Title CH-012 Transistor Curve Tracer Adapter for OSC		
Size B	Number http://www.thaikits.com	Revision 1.00
Date: 13-Dec-2013	Sheet of 1	
File: D:\CH-012.DDB	Drawn By:

Engineer Change Notice

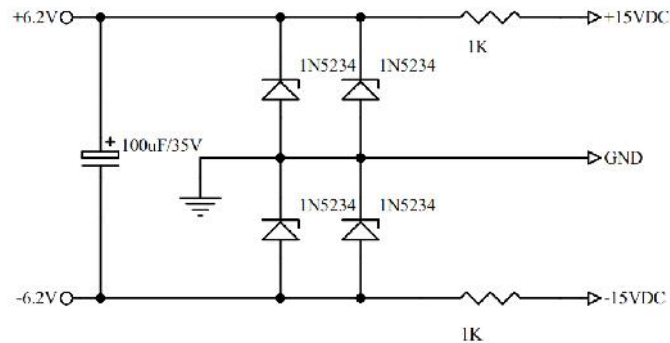
1. There are 2 options for 6.2V Zener diode.

1.1 In case, the kit has 4x 1N5234 which is 500mW, please install all 4 units.

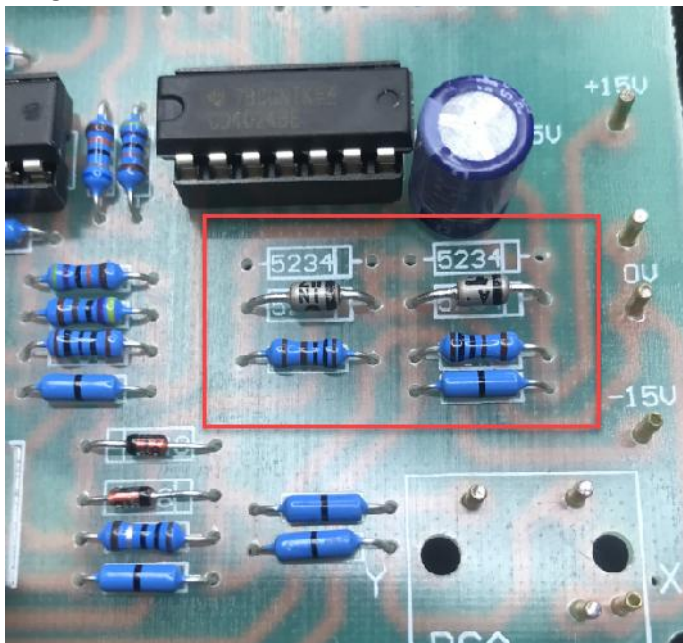
1.2 In case, the kit has 2 x 1N4735 which is 1W, please install only 2 units. Please refer to the image.
